Staff Report

Re: PLNPCM2020-00641 – 9th East Mixed Use and Multifamily

Design Review

PROPERTY ADDRESSES: 402 South 900 East and 410 South 900 East

NORTH ELEVATION - COLORED NORTH EL

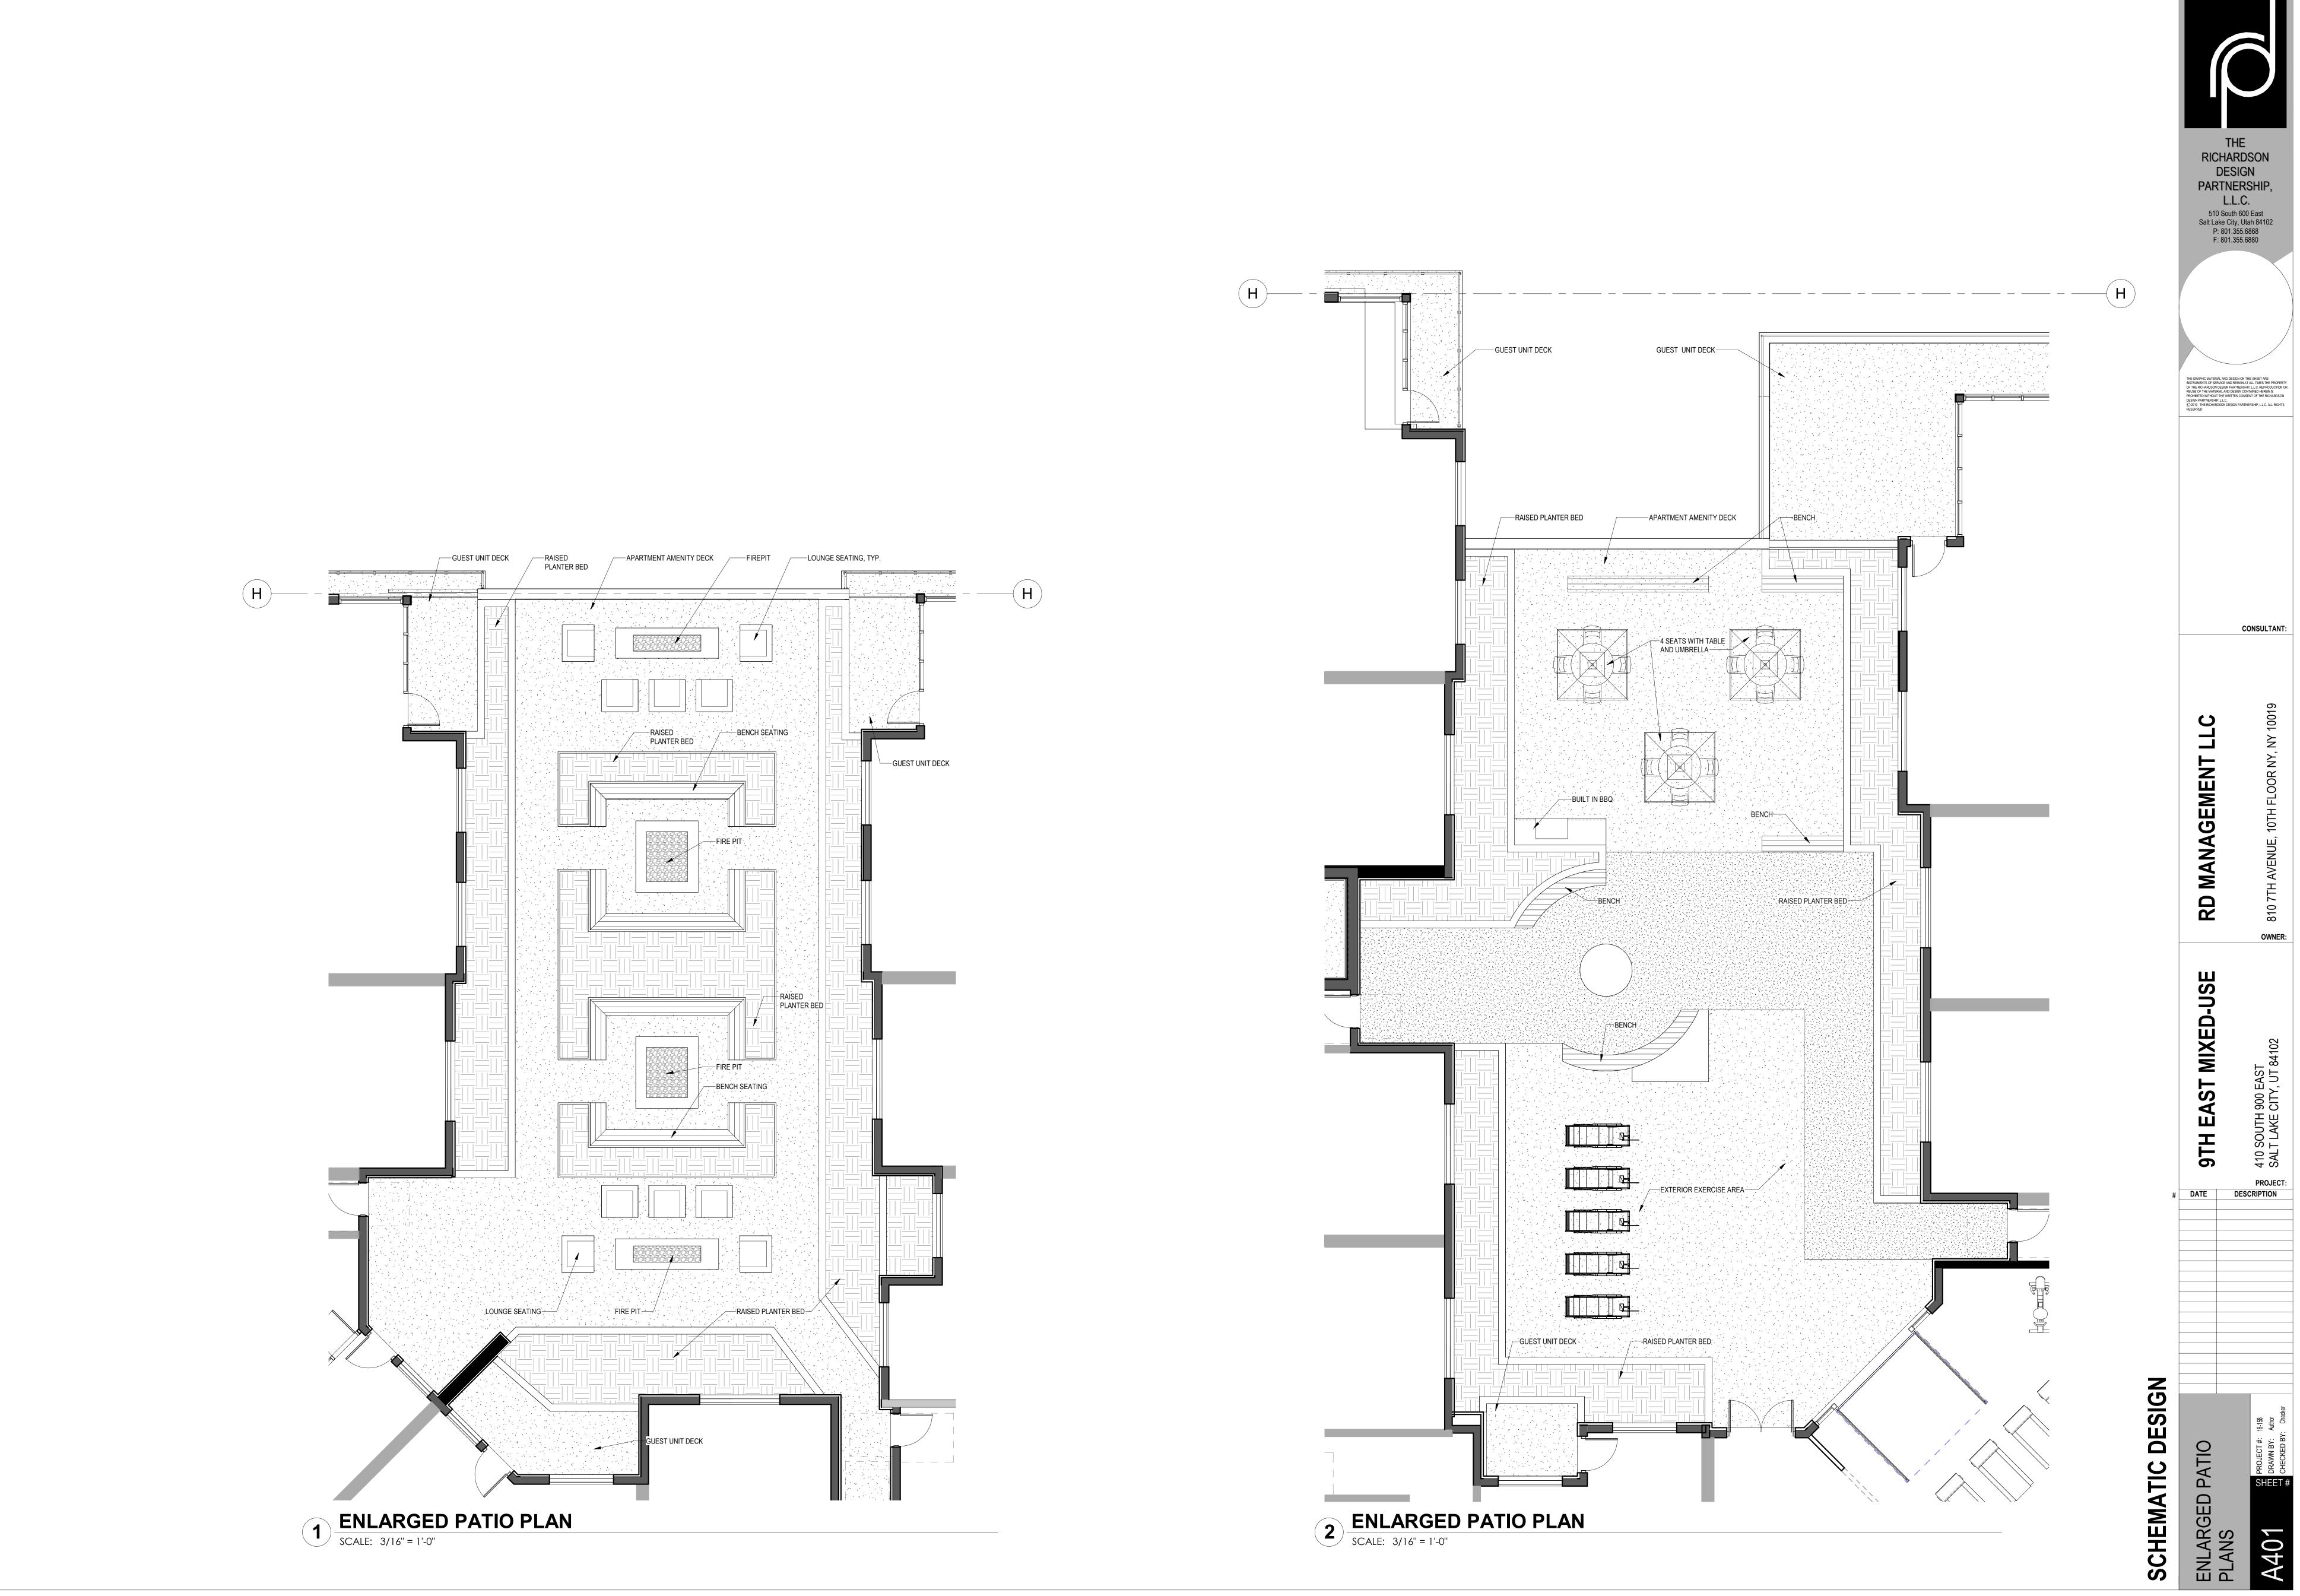
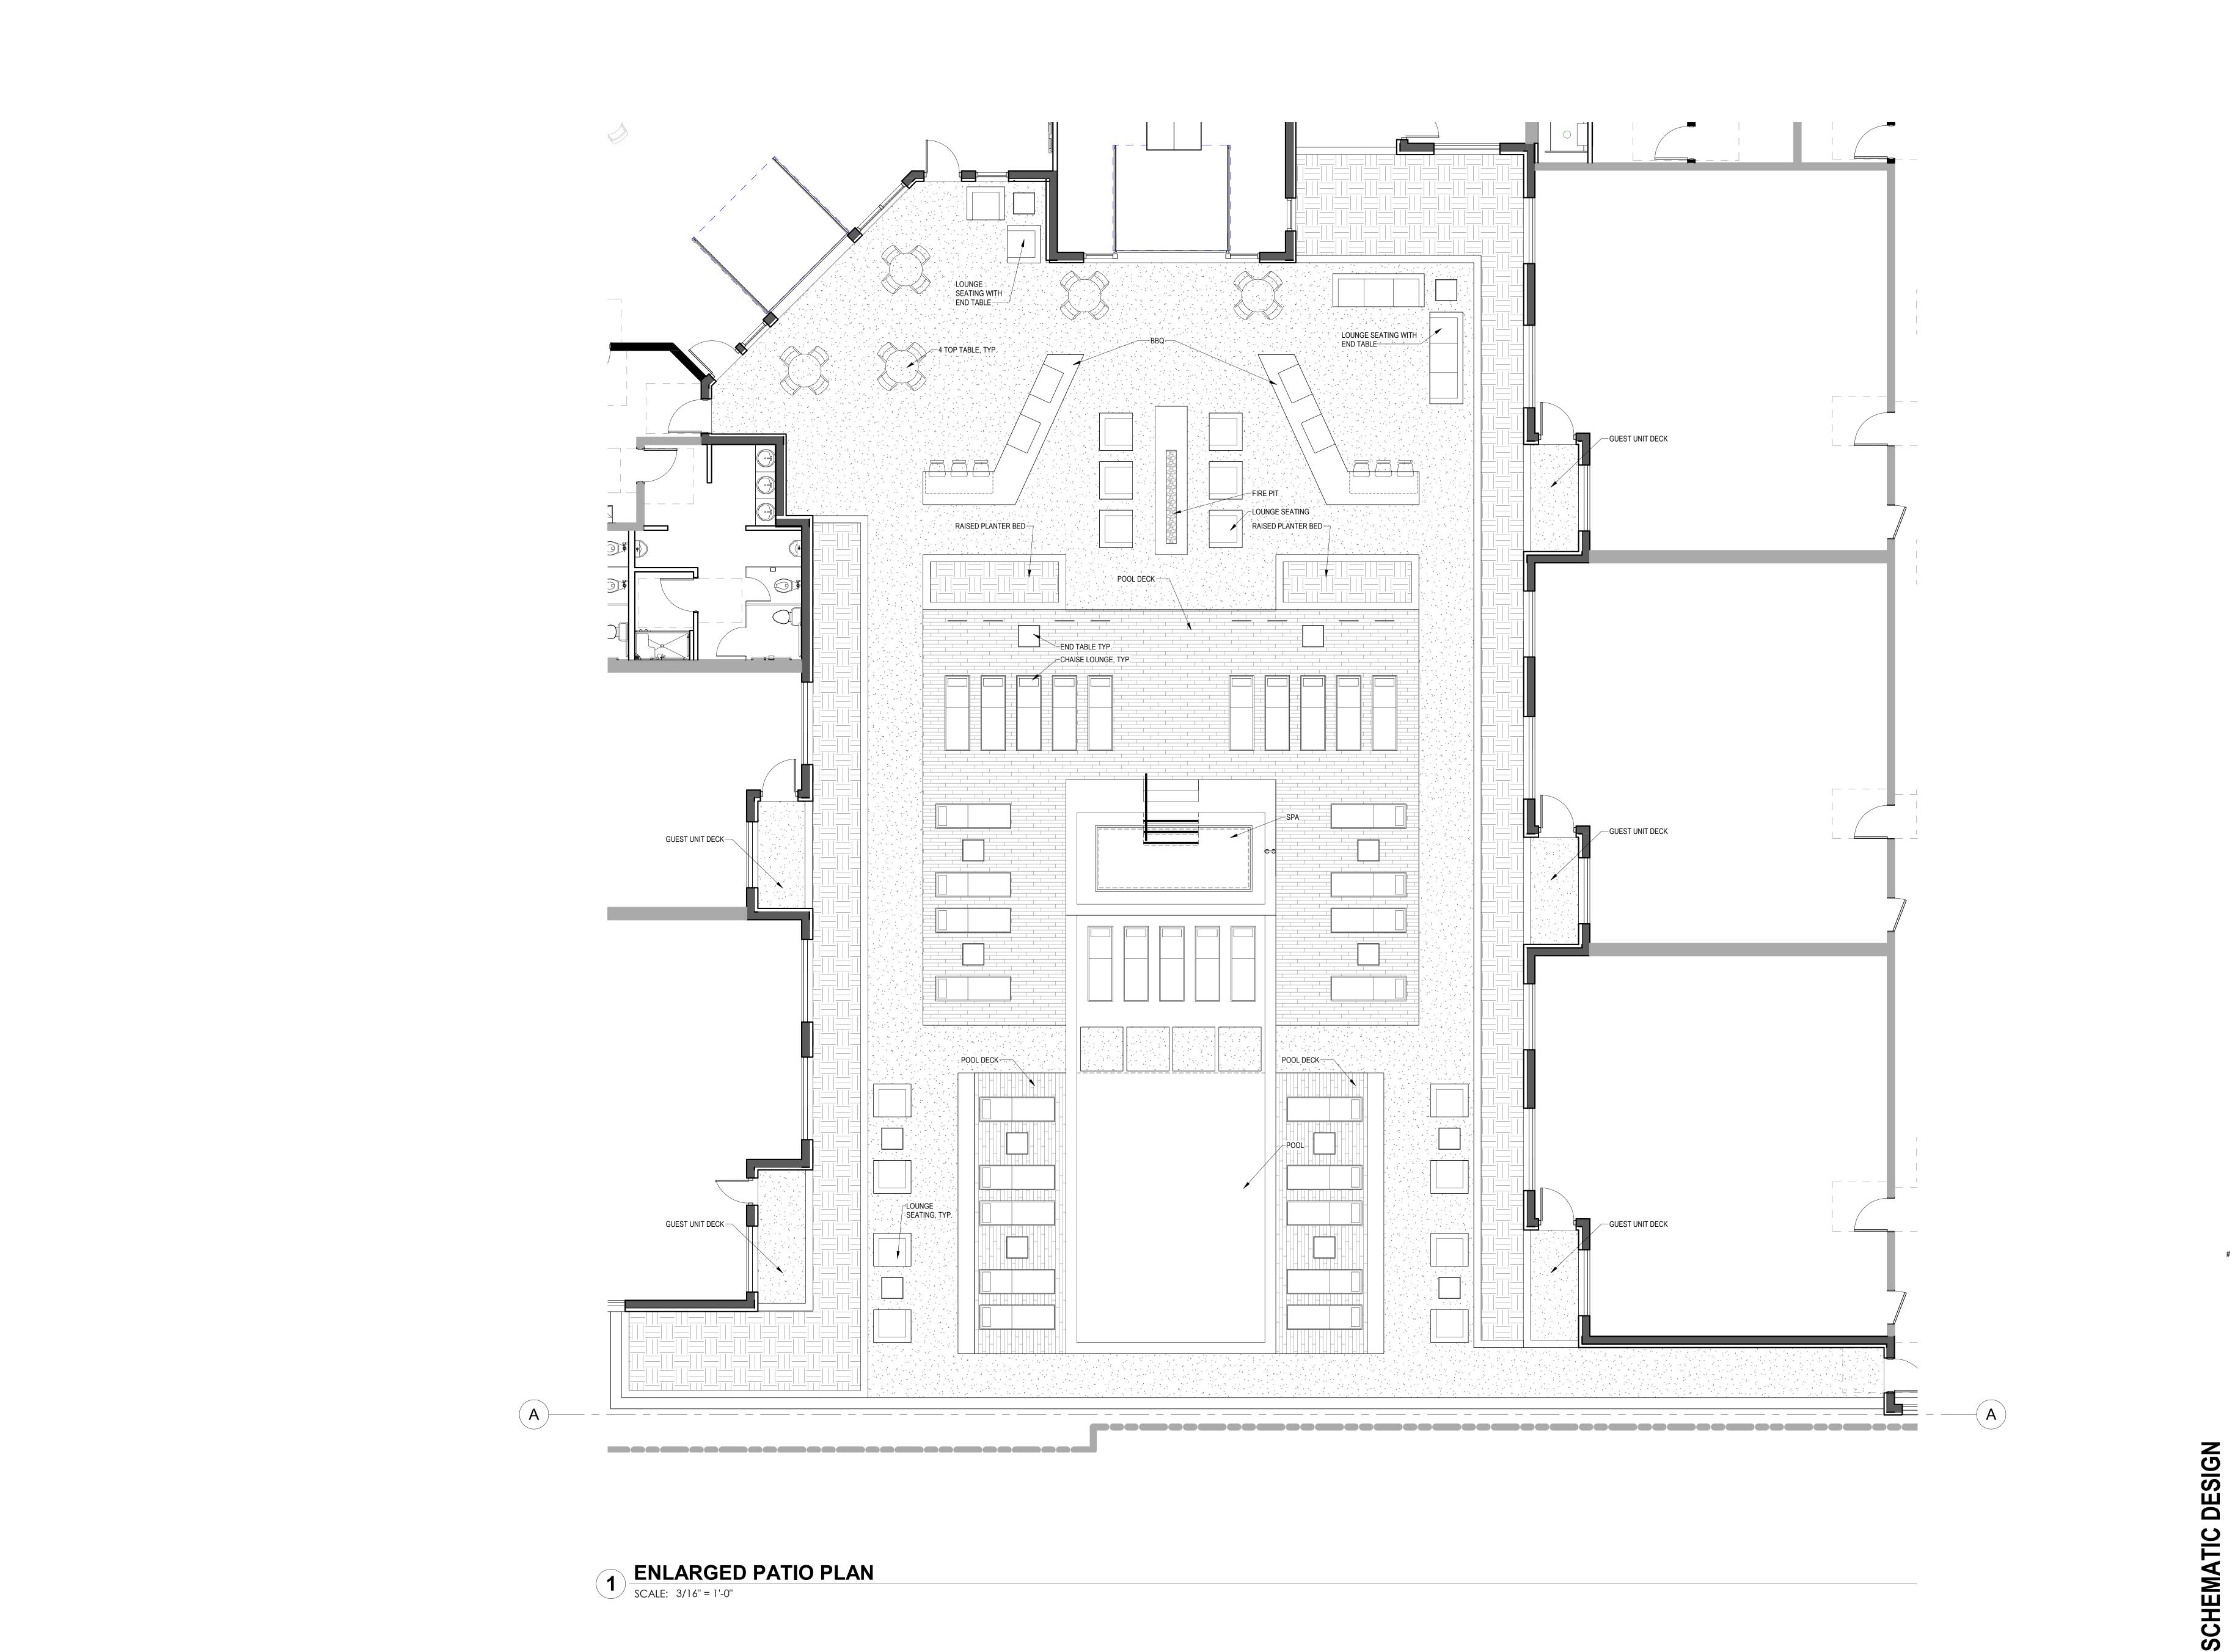
• 21A.26.078.F.2.a limits the use of EIFS and stucco to 10% of the upper level street facing façades. Please provide the percentage of EIFS and stucco for each façade.

North Elevation: Level 2 & up has a total of 17,304.52 sf of material not including windows or doors. The durable material is 65% (11,316.19 sf), brick and concrete. There is 4% (626.90 sf) of break metal material. There is 31% (5,361.43 sf) of a synthetic acrylic coating over rigid insulation that mimics a metal panel. We have provided a brochure from the manufacturer to further clarify the appearance of the material.

East Elevation: Level 2 & up has a total of 6387.49 sf of material not including windows or doors. The durable material is 62% (3936.94 sf), brick and concrete. There is 1% (45.41 sf) of break metal material. There is 37% (2405.14 sf) of a synthetic acrylic coating over rigid insulation that mimics a metal panel. We have provided a brochure from the manufacturer to further clarify the appearance of the material.

Response: Updated material calculations have been provided on the revised elevations.
